Supply and Demand Correlation

New Mexico – Gila Basin – Arizona Water Settlement Act

**U.S. Department of the Interior
Bureau of Reclamation
Phoenix Area Office**

Attachment A – Supply and Demand Correlation Comments/Responses

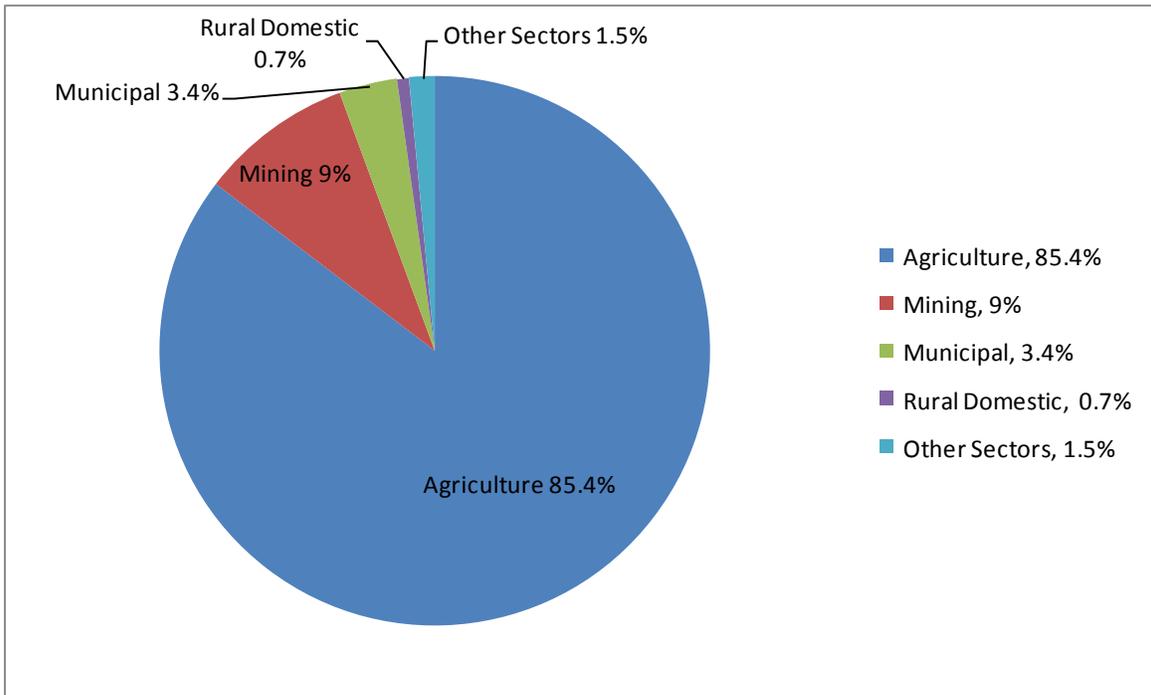
- 3. P9, section 2.1.2 through section 2.1.5: Comment:** This section apportions water demand by sectors. It would be useful to include a pie chart that allows relative proportions of demand by sector to be easily seen.

Response: A pie-chart has been added.
